**TENNESSEE VALLEY AUTHORITY  
SEQUOYAH NUCLEAR PLANT (SQN)  
UNIT 2**

**SEQUOYAH NUCLEAR PLANT UNIT 2  
REALISTIC LARGE BREAK  
LOSS OF COOLANT ACCIDENT ANALYSIS  
ANP-2655(NP)  
REVISION 1  
FEBRUARY 2008**

Sequoyah Nuclear Plant Unit 2  
Realistic Large Break LOCA Analysis

Figure 3-23 GDC 35 LOOP versus No-LOOP Cases

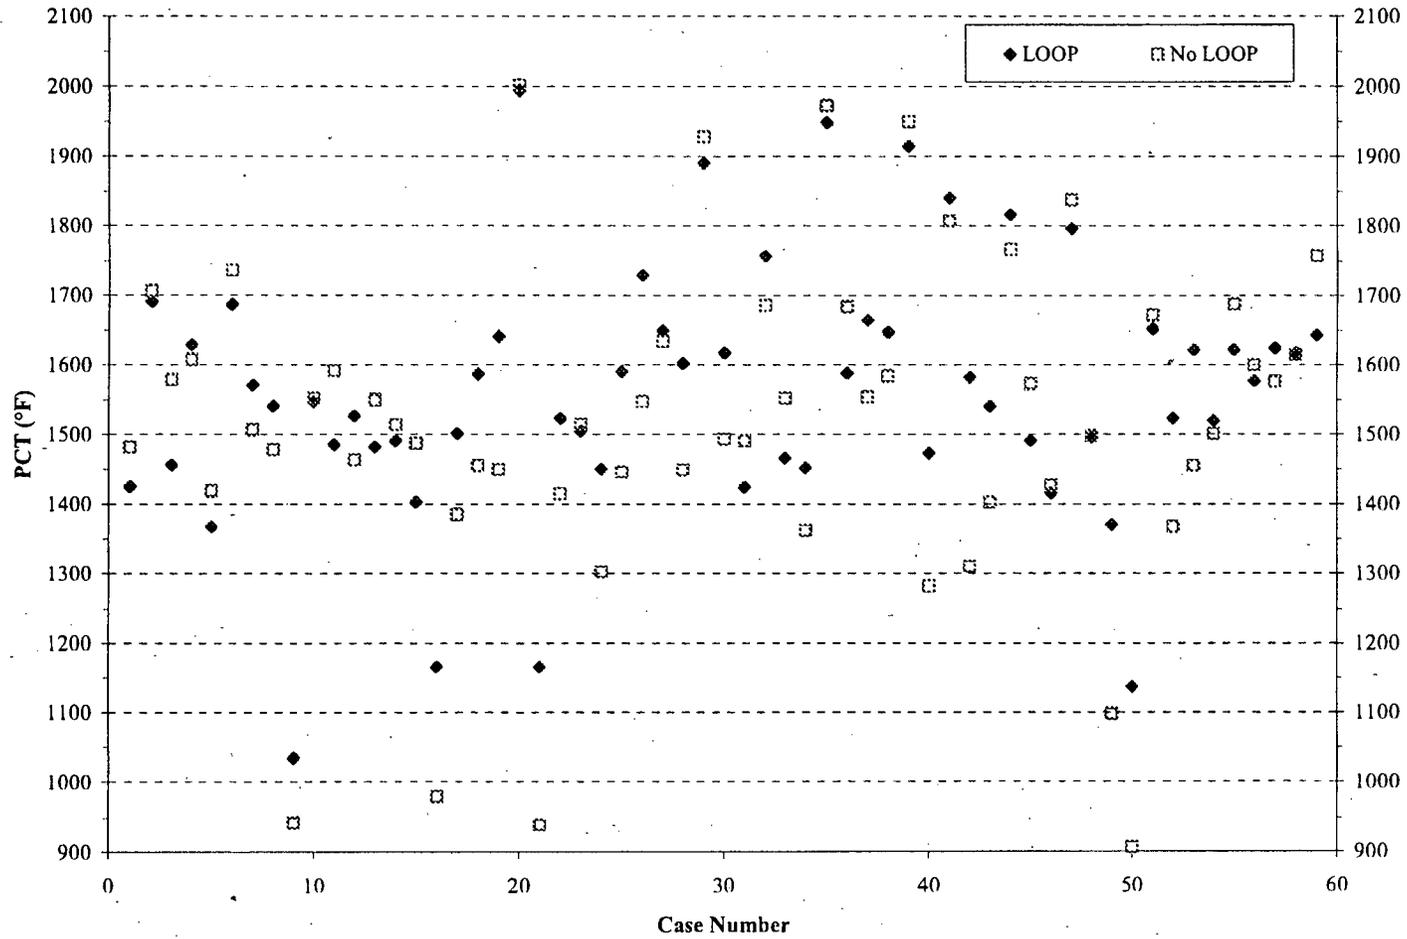
In concurrence with the NRC's interpretation of GDC 35, a set of 59 cases was run with a LOOP assumption and a second set with a No-LOOP assumption. The set of 59 cases that predicted the highest PCT is reported in Section 2 and Section 3, herein. The results from both case sets are shown in Figure 3-23. The effect on PCT results is expected to be minor.

In concurrence with the NRC's interpretation of GDC 35, a set of 59 cases each was run with a LOOP and No-LOOP assumption. The set of 59 cases that predicted the highest figure of merit, PCT, is reported in Section 2 and Section 3, herein. The results from both case sets are shown in Figure 3-23. This is a change to the approved RLBLOCA EM (Reference 1).

Figure 6-2 Rod Thermal Radiation in FLECHT-SEASET Bundle and in a 17x17 FA

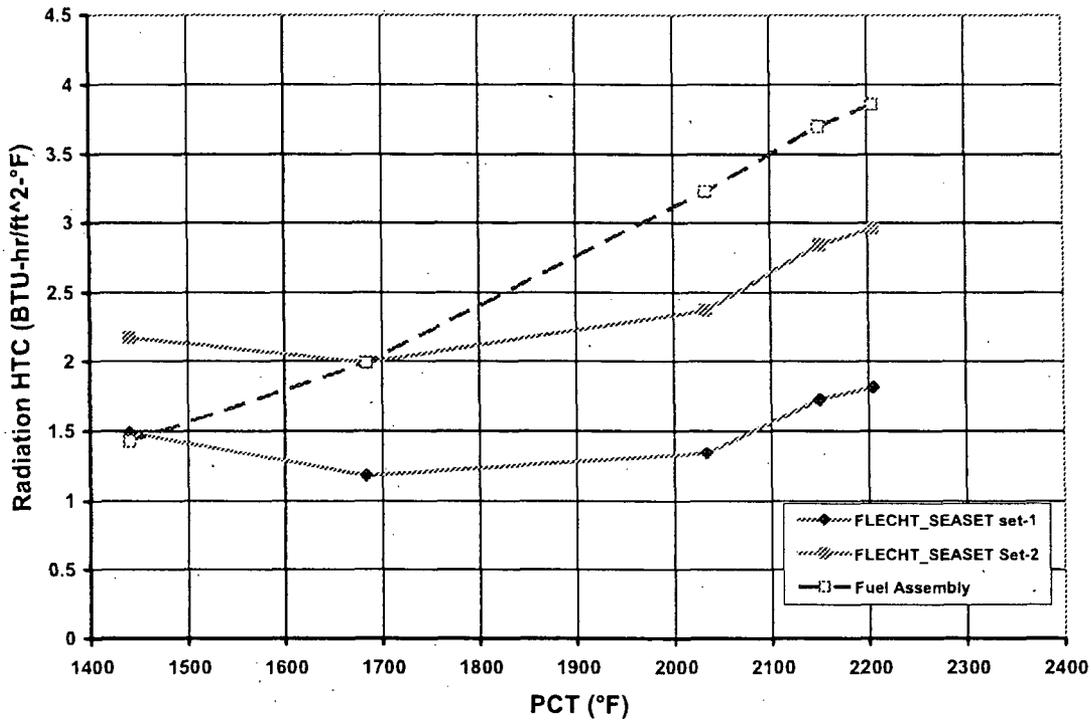
**Question:** *Provide justification that the S-RELAP5 rod-to-rod thermal radiation model applies to the SQN-2 core.*

Figure 6-2 shows the hot rod thermal radiation heat transfer for the two FLECHT-SEASET sets and for the plant set. The figure shows that for PCTs greater than about 1700 °F, the hot rod thermal radiation in the plant cases exceeds that of the same component within the experiments.

Figure 6-4 S-RELAP5 versus Closed Form Solution

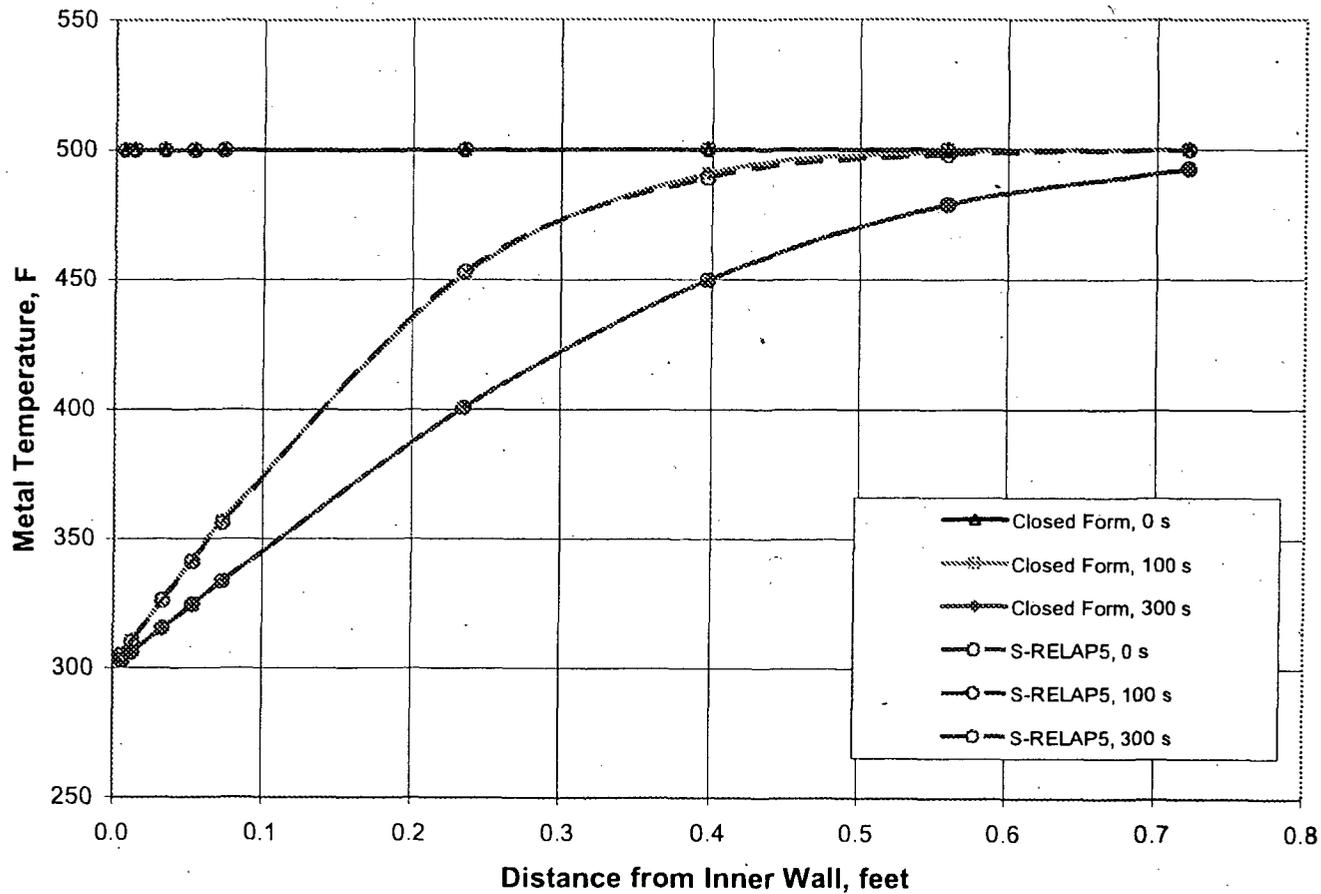
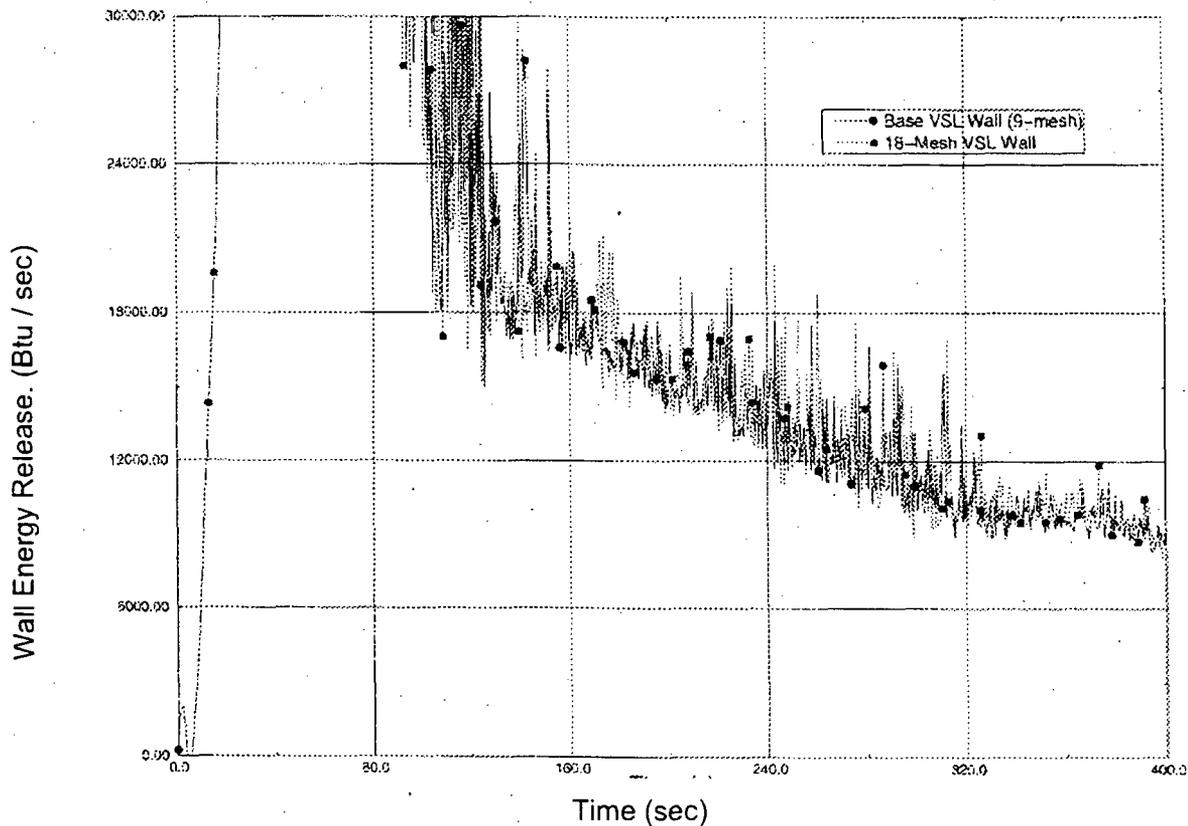
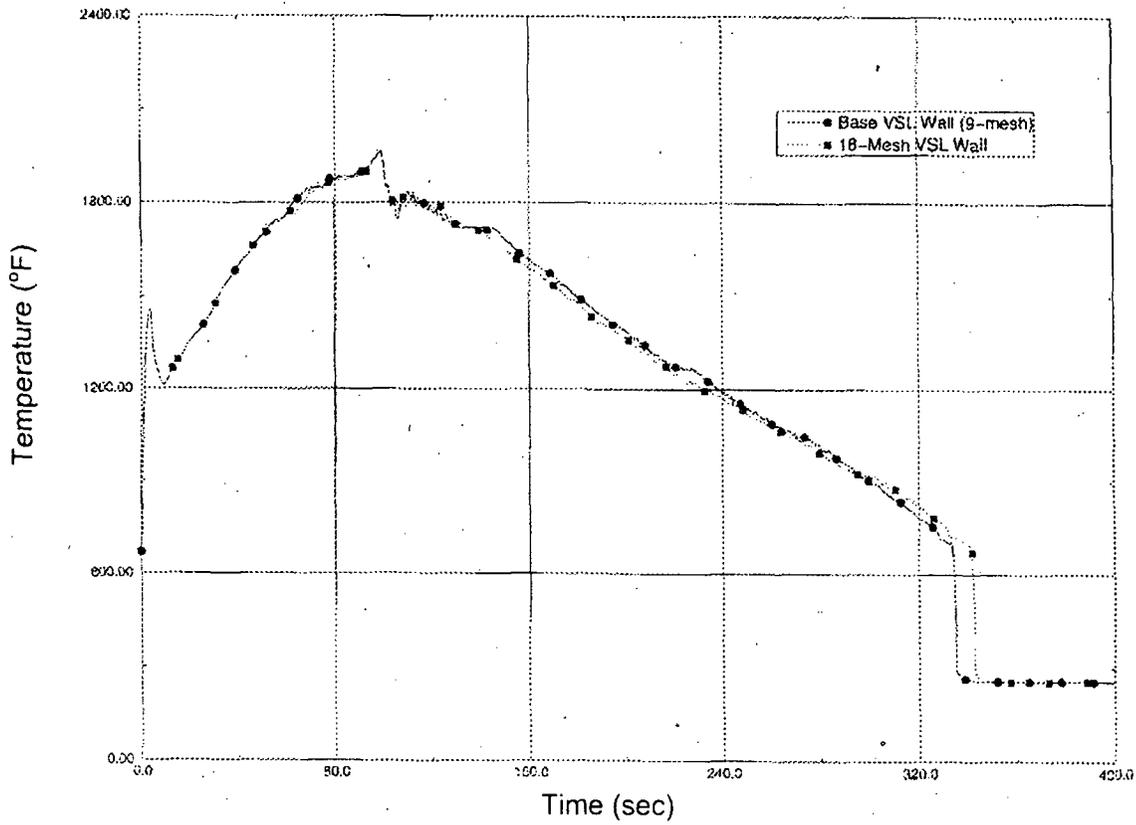
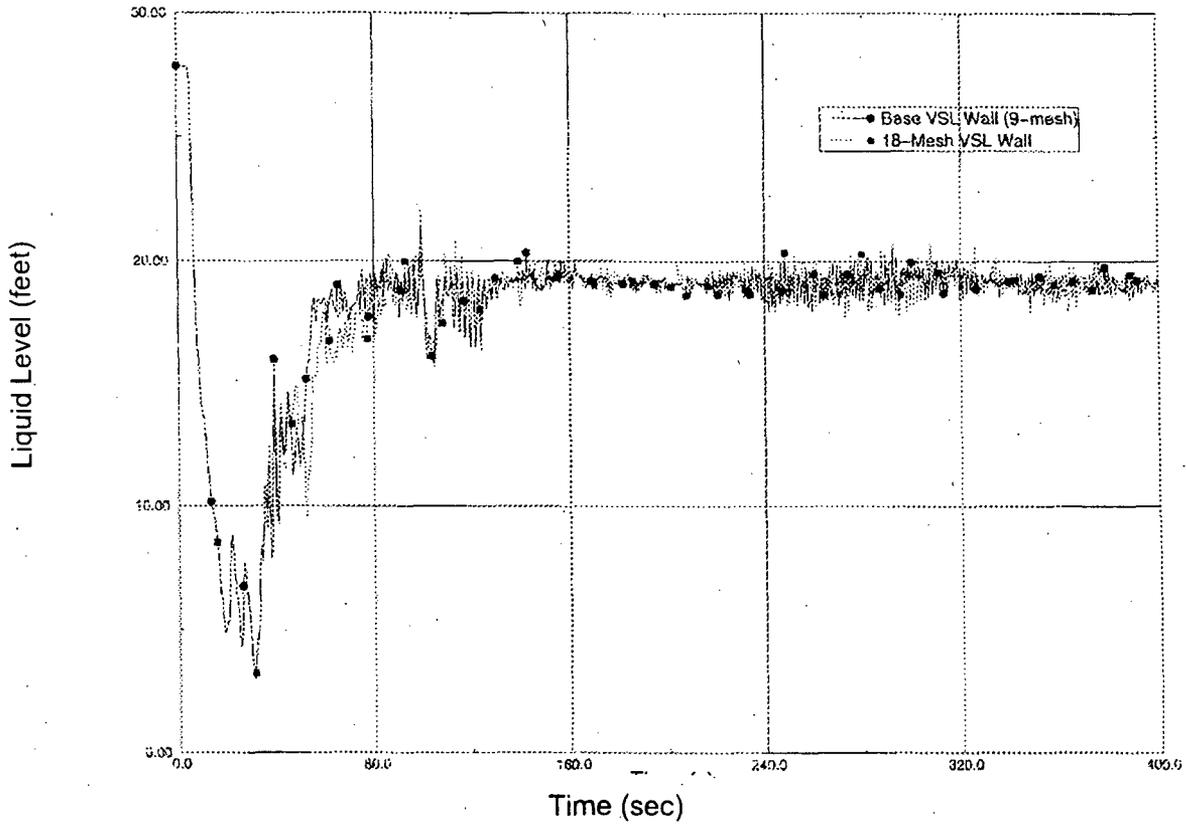
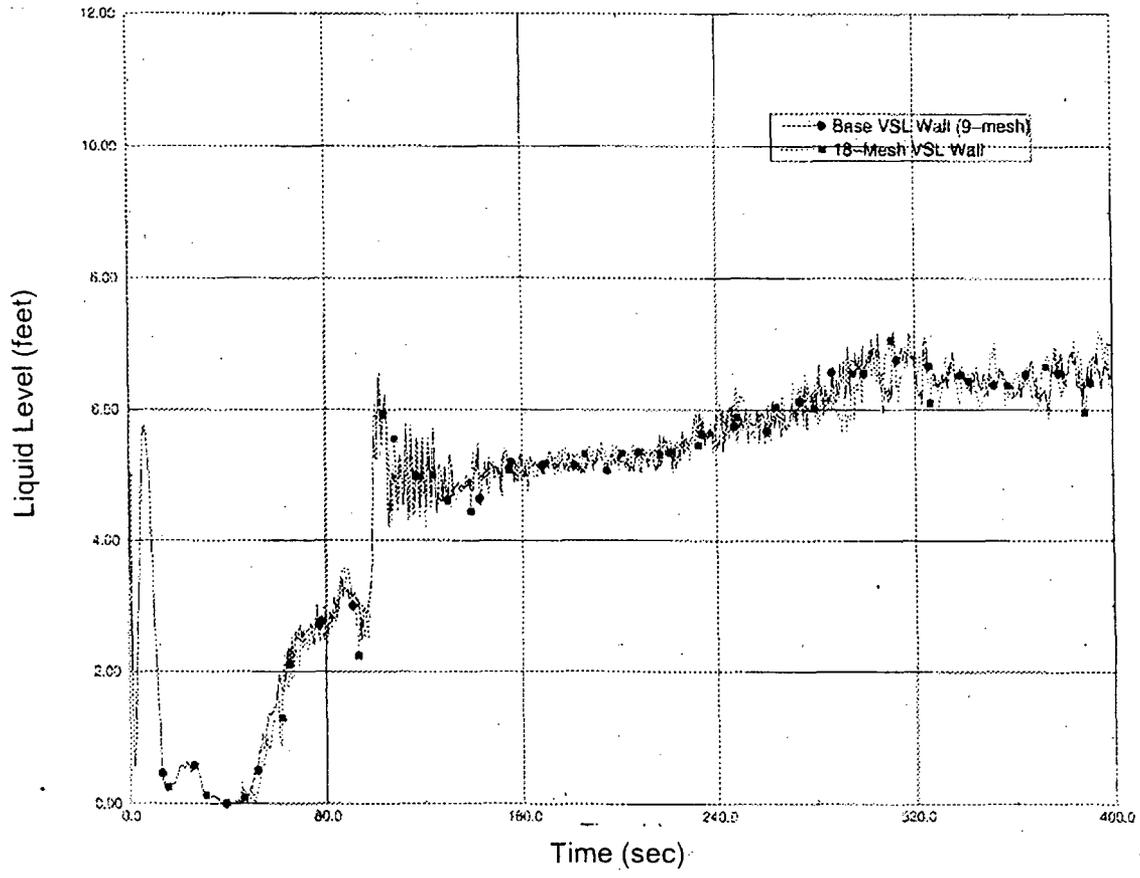
**Question:** *If the PCT is greater than 1800°F or the containment pressure is less than 30 psia, has the Sequoyah Unit 2 downcomer model been rebenchmarked by performing sensitivity studies, assuming adequate downcomer noding in the water volume, vessel wall and other heat structures?*

The conditions of the benchmark are  $T_i = 500$  °F and  $T_o = 300$  °F. The mesh spacing in S-RELAP5 is the same as that used for the downcomer vessel wall in the RLBLOCA model. Figure 6-4 shows the temperature distributions in the metal at 0.0, 100 and 300 seconds as calculated by using Equation 1 and S-RELAP5, respectively. The solutions are identical confirming the adequacy of the mesh spacing used in the downcomer wall.

As additional verification, a typical 4-loop plant case was used to evaluate the adequacy of the mesh spacing within the downcomer wall heat structure. Each mesh interval in the base case downcomer vessel wall was divided into two equal intervals. Thus, a new input model was created by increasing the number of mesh intervals from 9 to 18. The following four figures show the total downcomer metal heat release rate, PCT independent of elevation, downcomer liquid level, and the core liquid level, respectively, for the base case and the modified case. These results confirm the conclusion from the exact solution study that the mesh spacing used in the plant model for the downcomer vessel wall is adequate.

Figure 6-21 Energy Addition in Lower Compartment

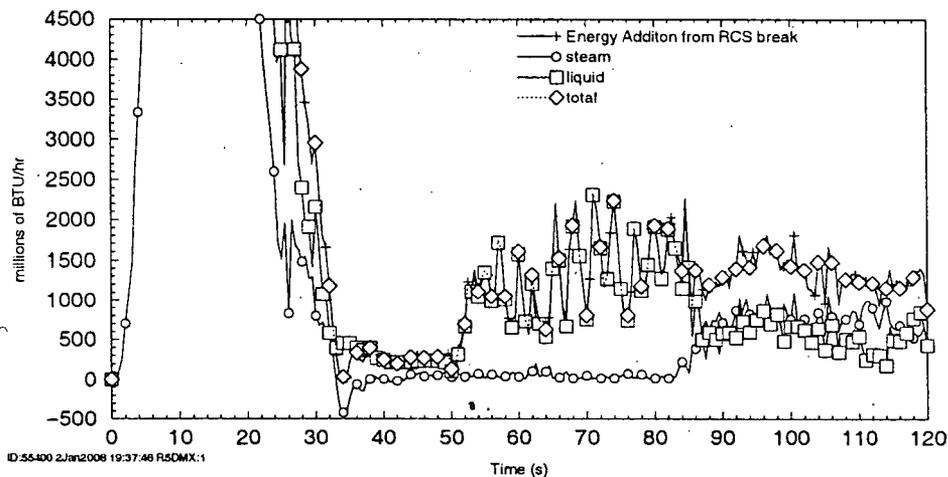
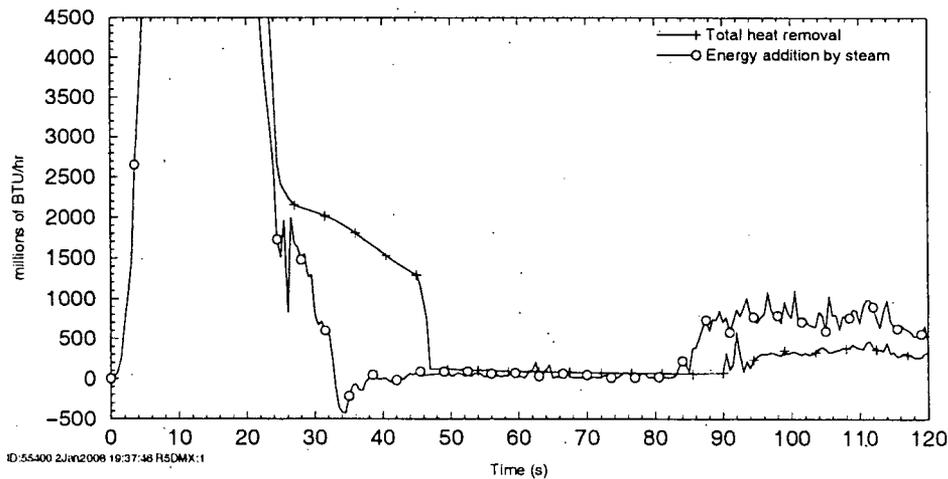
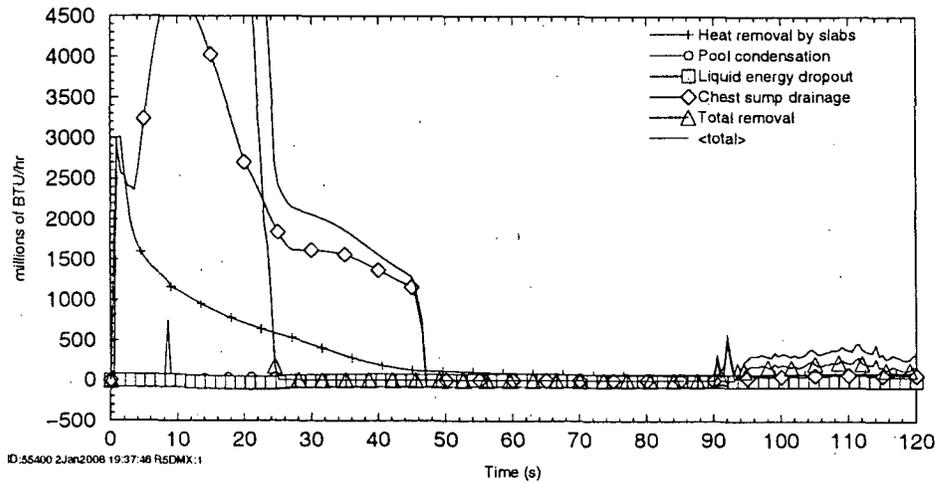
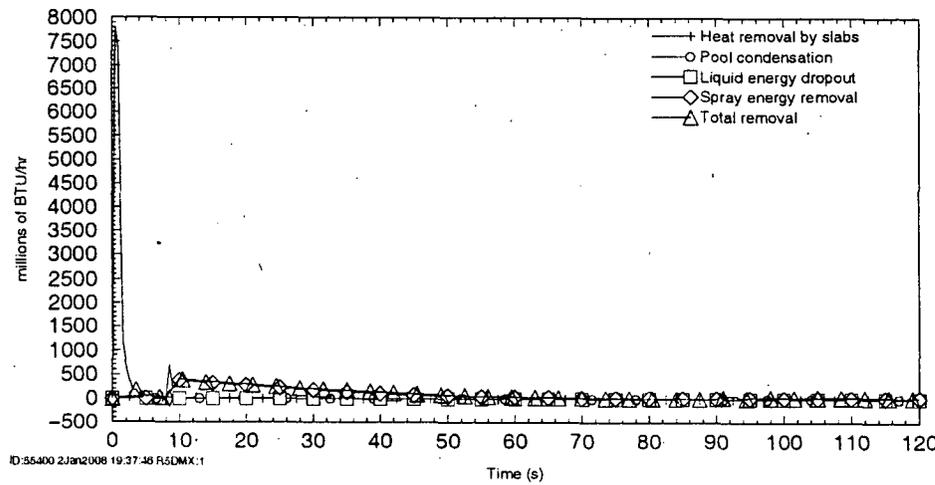
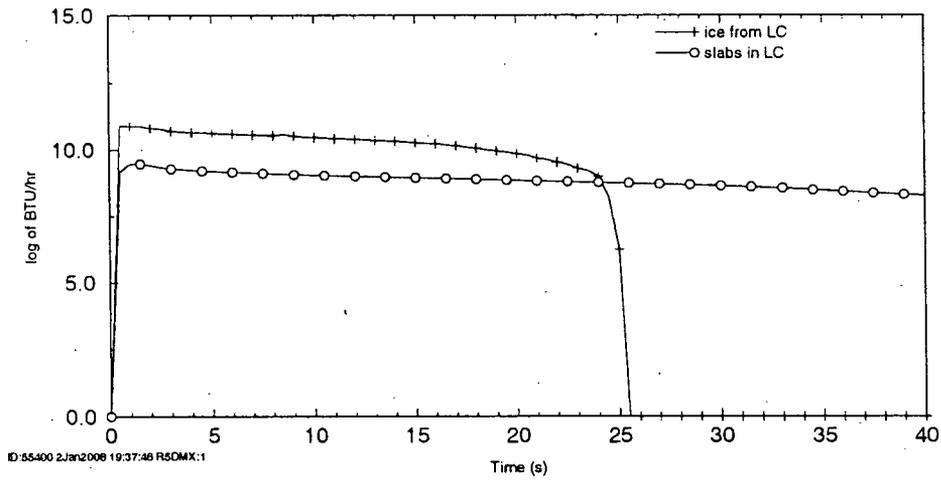
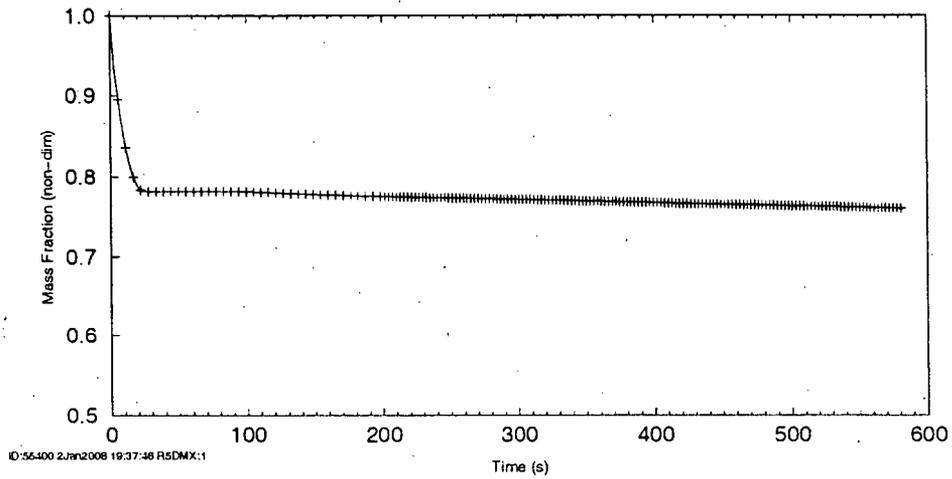
The following are a set of containment plots that are produced to supplement the NRC's review of the Sequoyah Unit 2 RLBLOCA analysis.
